ITEM FOR ENVIRONMENTAL COMMISSION AGENDA

NAME & NUMBER OF PROJECT: 305 S. Congress Planned Unit Development, C814-89-0003.02

REQUEST: To amend the current PUD.

STAFF RECOMMENDATION: Current proposal is not considered environmentally superior and thus not recommended but would be with the following conditions.

Options to Avoid Tree Removal

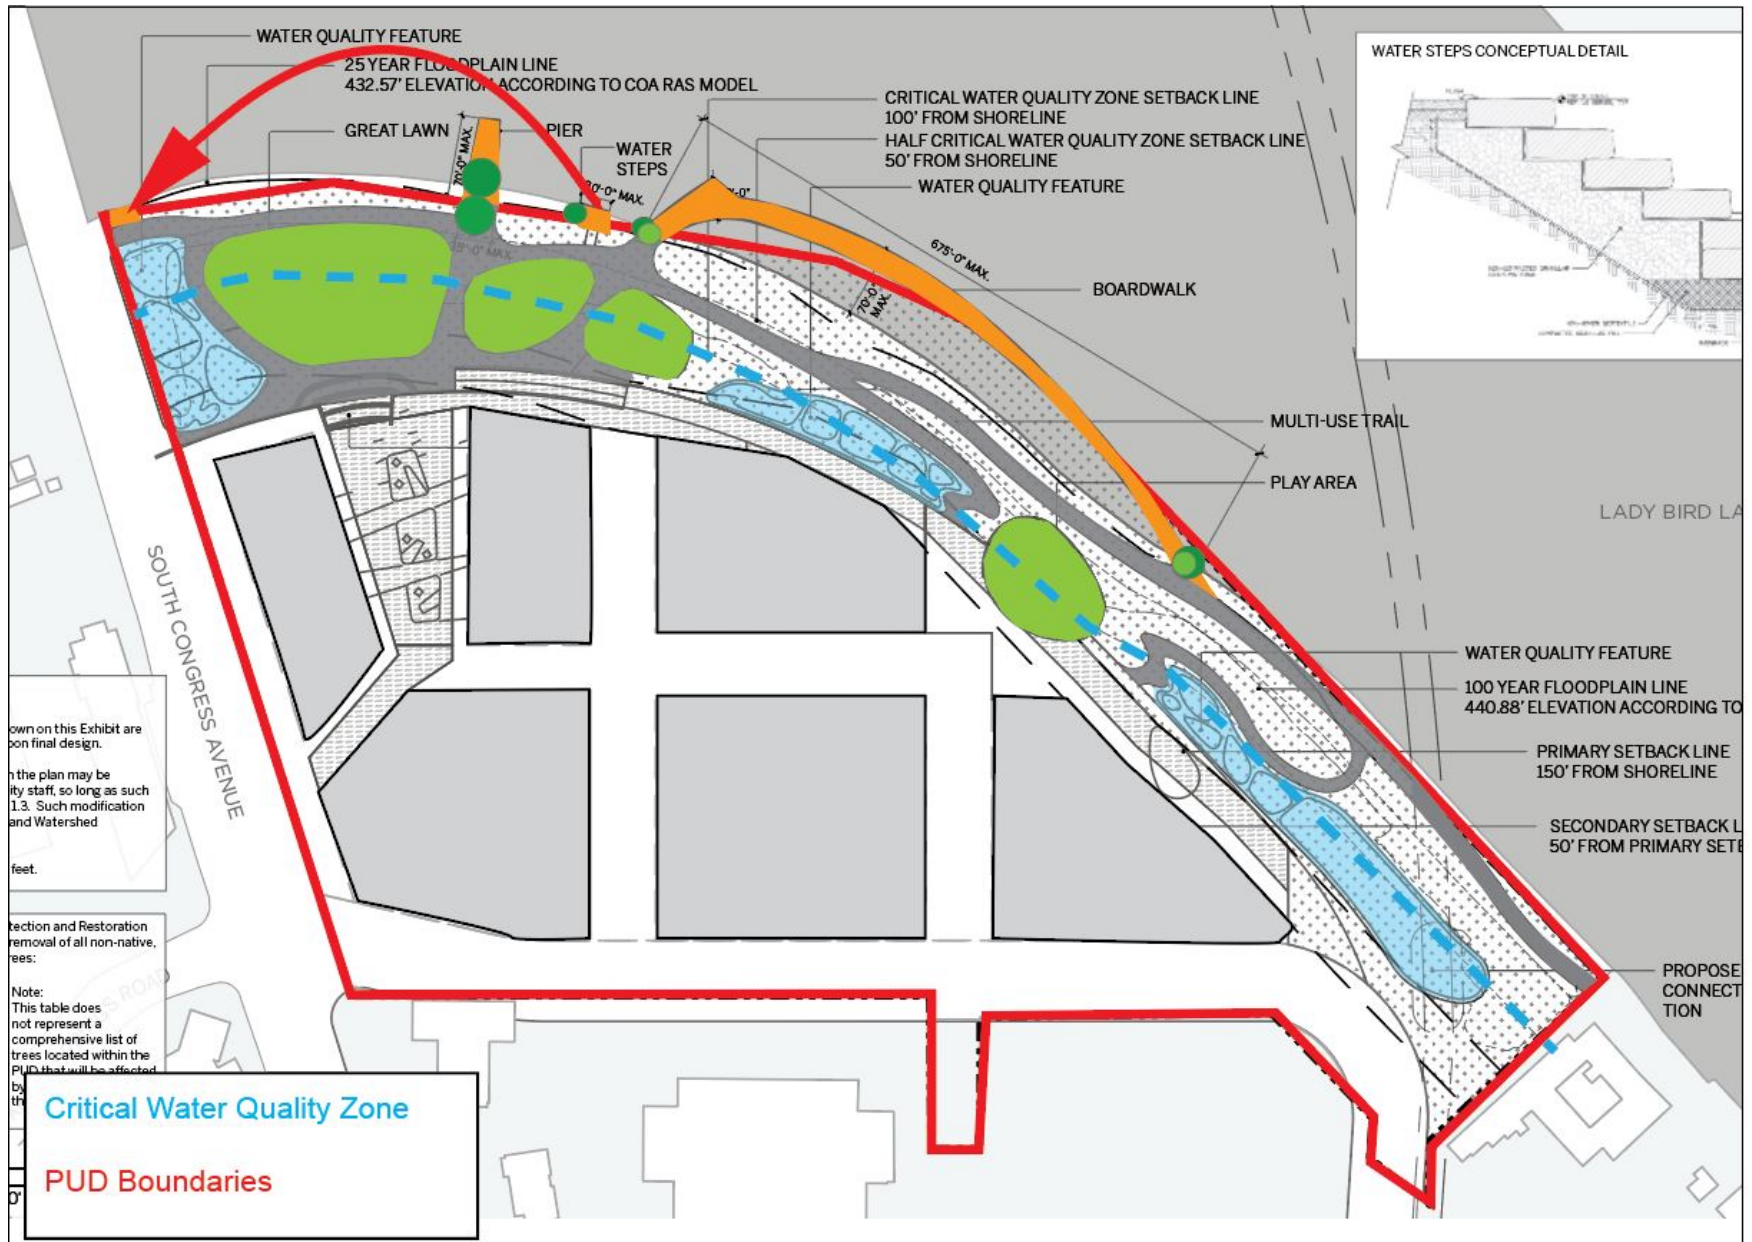
5. Complete a Parkland Improvement Agreement that includes maintenance for the water quality ponds located within the parkland.
6. Move and narrow the proposed pier to a location that does not impact existing trees.

Parkland Dedication

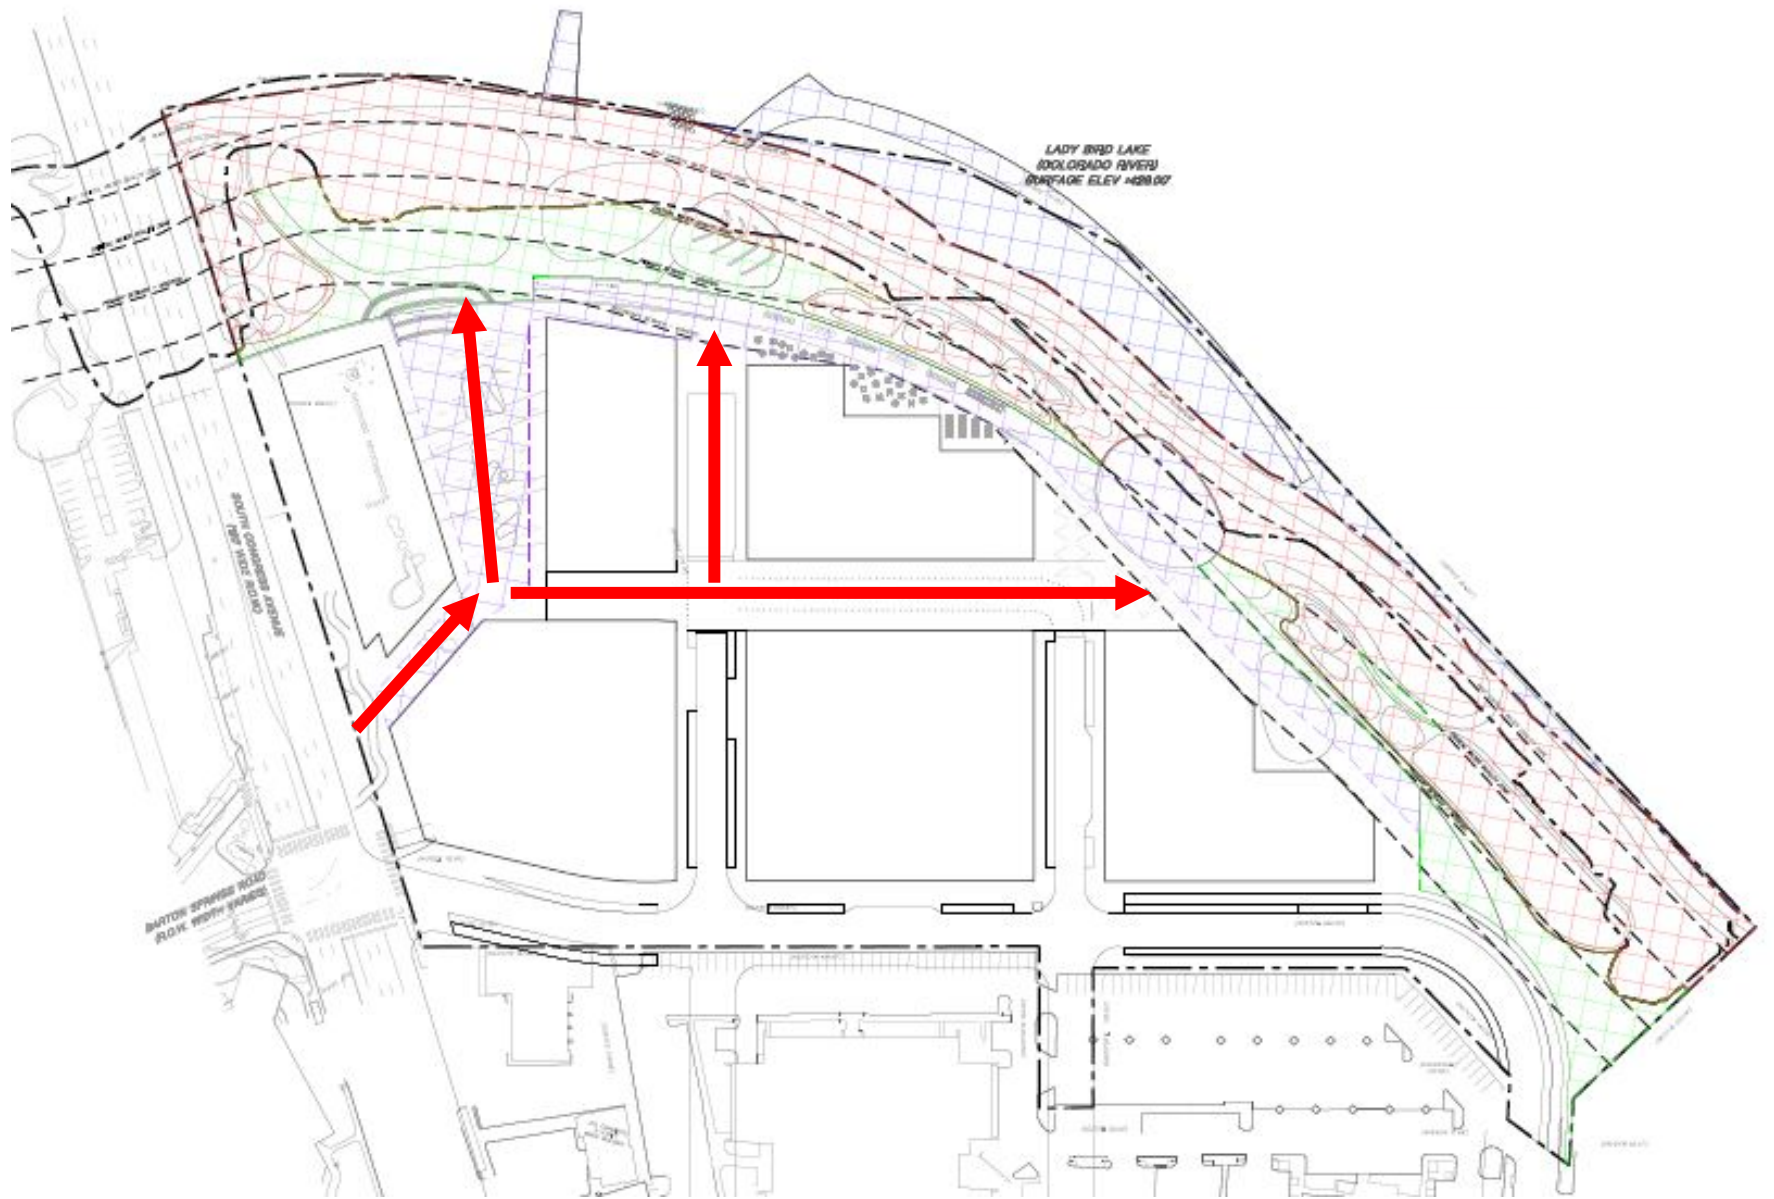
1. Except for items listed in the amended ordinance, the PUD will be subject to the code at the time of site plan application.
2. Dedicate by deed the area of approximately 6.53 acres as public parkland located along the Lady Bird Lake frontage; and 1.59 acres of parkland easements. The parkland and easements shall not be restricted.

3. Provide public equitable access from S. Congress ROW to the Hike and Bike trail that does not force visitors through the development.
4. Provide \$100 over what is required by current code to build park amenities.
